SERVICE BULLETIN

SERVICE BULLETIN		No.: MSB-99E55-503	
Date: 1999-12-15		<Model> (EC,EXP) L200	<M/Y> 97-10 (K00)
Subject: OMISSION OF DISASSEMBLY / REASSEMBLY OF A/C COMPRESSOR ASSEMBLY			
Group: HEATER, A/C & VENTILATION	Draft No.: 99SY060115

Omission has been rectified of a description of the disassembly / reassembly of the A/C compressor assembly under Compressor and Tension Pulley.

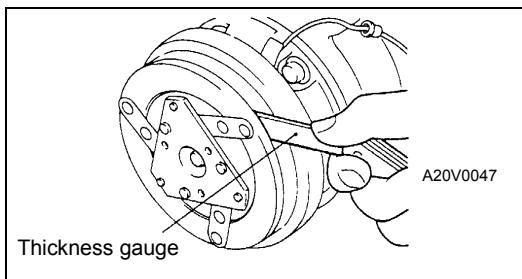
<Added>

B991367	MB991367	Special spanner	Removal and installation of armature mounting nut of compressor.
 B991386	MB991386	Pin

**COMPRESSOR MAGNETIC CLUTCH AIR GAP CHECK**

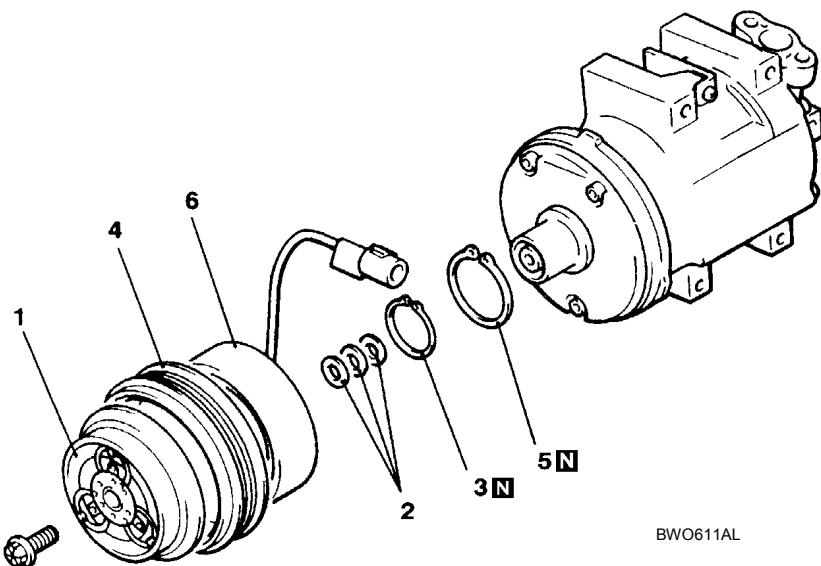
Check whether or not the air gap of the clutch is within the standard value.

Standard value: 0.3 – 0.6 mm

DISASSEMBLY AND REASSEMBLY

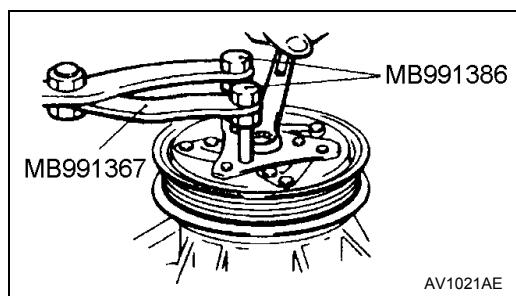
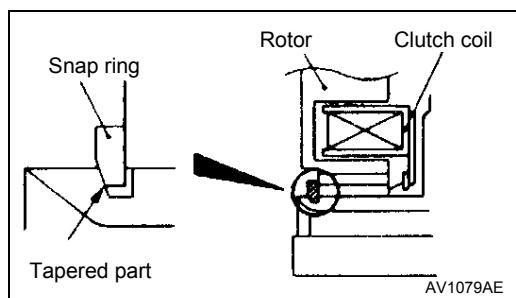
◀A▶ Magnetic clutch disassembly steps

▶B◀ • Air gap adjustement

1. Armature plate
2. Shims

▶A◀ 3. Snap ring

4. Rotor

5. Snap ring

6. Clutch coil

▶A◀ SNAP RING INSTALLATION

Install the snap ring so that the tapered surface is at the outer side.

<Added>
